Oyster Creek Generating Station  
Facility Operating License No. DPR-16  
NRC Docket No. 50219

Subject: Clarifications to Responses to NRC Request for Additional Information related to Severe Accident Management Alternatives (SAMA) for Oyster Creek Generating Station (TAC No. MC7625)

**Clarifications Associated with SAMA RAI Responses**

Figure 1c-1 Review Process for Oyster Creek PRA Model

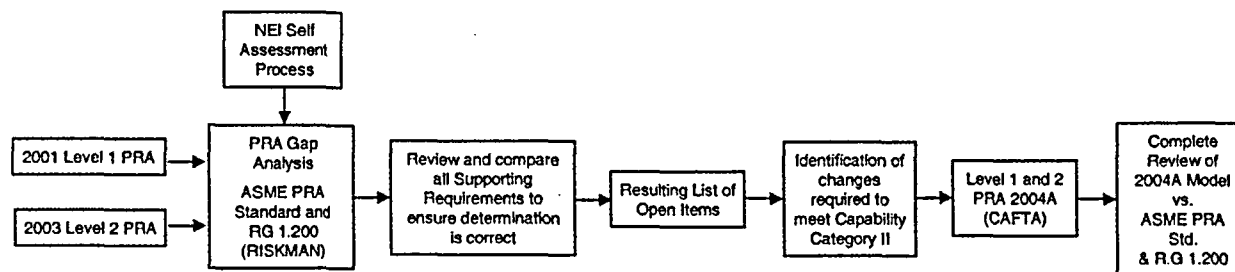
*The response to this RAI indicates that the results of the 2004A PRA model were "re-reviewed to establish the number of gaps that remained following the update" and "the self-assessment performed for the 2004A model and documentation also applies to 2004B".*

*Was the 2004A analysis subjected to a complete self assessment or was the focus of the re-review limited to those gaps found in the 2001 PRA? Of concern is the completeness/applicability self-assessment of the 2001 PRA relative to the 2004A model considering the extensive changes from the 2001 model to the 2004 model not the least of which is the change from support state (RISKMAN) modeling to linked fault tree (CAFTA) modeling.*

The Oyster Creek 2004A model, documentation, and results were subjected to a complete self assessment to ensure that they reflected the insights from the RISKMAN model and the model changes made during the 2004A model preparation.

AmerGen performed the analysis of the "gaps" of the 2001 Level 1 PRA and the 2003 Level 2 / LERF PRA relative to the ASME PRA Standard [1] and the RG 1.200 [2] changes by direct comparison between the Standards and the PRA. The NEI self-assessment process was used as a second check, but was not a primary input. It was used to ensure that no deficiencies that had previously been pointed out continued to persist. The assessment was performed on the model and documentation compared with the two documents, Ref. [1] and [2].

The 2004A model was targeted to comply with the ASME PRA Standard. The areas of compliance in the 2001 PRA model were retained and updated using a consistent methodology to meet Ref. [1] and [2].

Following development of the 2004A model, it was then completely re-assessed using the Ref. [1] and [2].

Figure 1c-1 summarizes this process.
